Re: Item No. 5 of the Homelessness and Poverty Committee Meeting for June 9, 2022, Council File 22-0496 – Proposal to Enter into Disposition and Development Agreement without Final Plans, Entitlements or Proof of Proper CEQA Exemption (Reese Davidson Project, VTT-82288; ENV-2018-6667-SE; CPC-2018-7344-GPAJ-VZCJ-HD-SP-SPP-CDP-MEL-SPR-PHP; Related Council File Nos. 21-0829 and 21-0829-S1)

Re: Agenda Item 1 – Special Meeting of the Planning and Land Use Committee – Council File 21-0829-S1: (1) Corrected Resolution and Findings for a General Plan Amendment to the Venice Community Plan and the Certified Venice Local Coastal Program Land Use Plan (LUP) and (2) Report for the City Attorney and draft Ordinance Amending the Venice Coastal Zone Specific Plan to create a new Subarea A and establish new land use and development regulations by amending Section 10 of the Specific Plan, amending the Existing Zoning Map from OS-1XL and RD1.5 to (T)(Q)C2-1L-O, and amending the Existing Zoning Map to remove the proposed Alberta Avenue right-of-way between North Venice Boulevard and South Venice Boulevard, and replacing it with (T)(Q)C2-1LO; 2102-2120 S. Pacific Avenue, 116-128 E. Venice Blvd, 204-2

FIGURE 3 – Boat Launch Ramp Access with the Propose Project

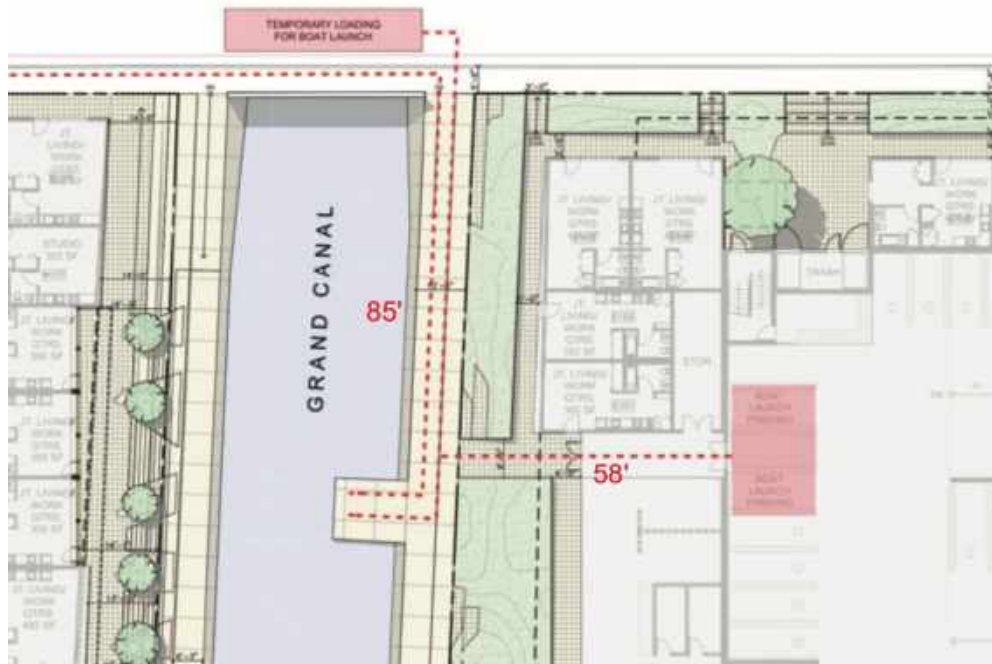
In contrast, as shown in **Figure 3**, with the proposed Project, access to the boat launch will be difficult, and may be impossible for some watercraft. As shown in **Figure 3**, the Project provides inside the east public parking garage two spaces for vehicles bringing boats to the Canal. These spaces appear to be standard parking spaces and are only 18 feet in length. In order for persons using these spaces, the boats must be small so they can be carried through two building doors and through landscaped areas to reach the boat launch.

These parking spaces do not serve boats transported on trailers. Not shown in Figure 3, a single “long” space for a vehicle and boat trailer is shown on the Exhibit A approved project plans for the west parking garage. Because this single space is located just inside the parking gate for the west garage, there is already concern that the location of the space is impossible to negotiate. Linked with this single space is a temporary loading zone space in the south lane of North Venice Boulevard, for long boats while loading and unloading. This will block a lane of traffic while unloading, loading and hanging out in the zone.

FIGURE 5 – Project Pedestrian Access for Beach Parking Users

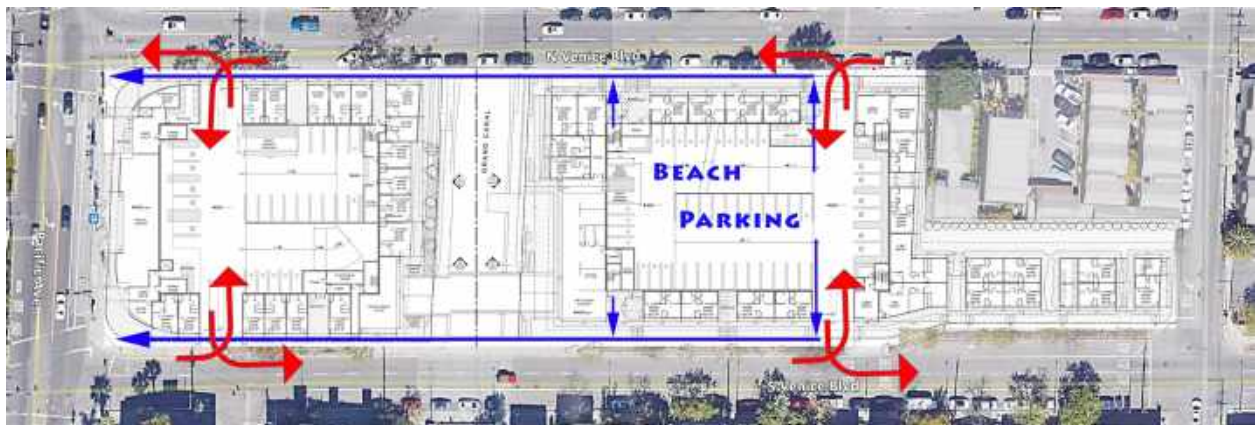
As shown in **Figure 5**, the proposed Project eliminates public parking on the western portion of the Project site thus moving 40% of beach parking 500 feet further from the beach, forces beachgoers to use the new eastern parking structure and to access crosswalks at Pacific Avenue by walking along the substandard (6-feet wide with obstructions) sidewalks on North and South Venice Boulevards, and to cross Project parking driveways. Changes resulting from the Project thus represents a beach access inconvenience and, to the degree that they decrease pedestrian safety, a public welfare impact.

Figure 1. Los Angeles County, Department of Public Works, Flood Zone Determination; 200 N. Venice Boulevard, April 21, 2021. FEMA Flood Zone AE, minimum base flood elevation (BFE) 8 ft NAVD88. Project site outline by red dashed line.

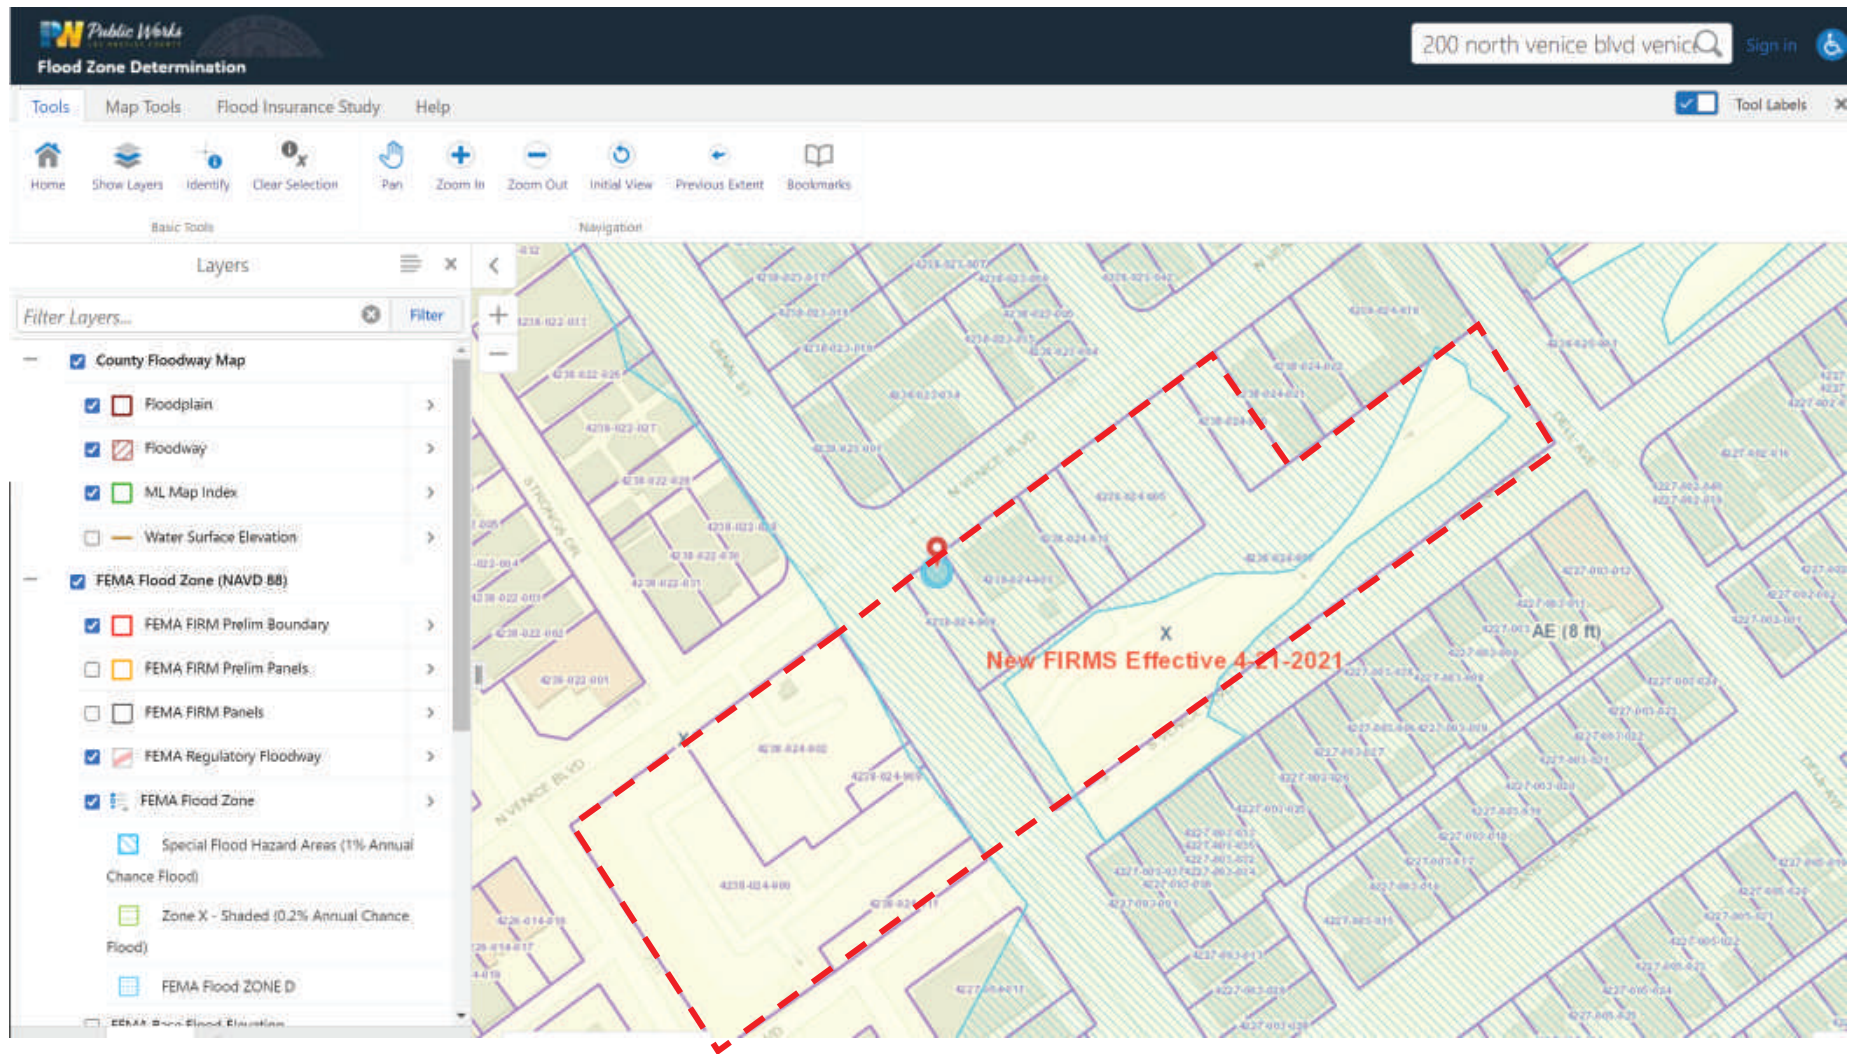
In April 2021, FEMA updated the Flood Maps for the County of Los Angeles. These maps depict regional flooding based on topography and specific storm return periods. The site is mapped partially within Zone AE BFE of eight (8) feet NAVD88). (See Figure 1 appended). This means that at present, the site has a 1% chance of flooding to this level annually. Typical project design standards are that the lowest horizontal structural member should be two (2) feet above the BFE. A summary of areas with a 1% annual chance of flooding are as follows:
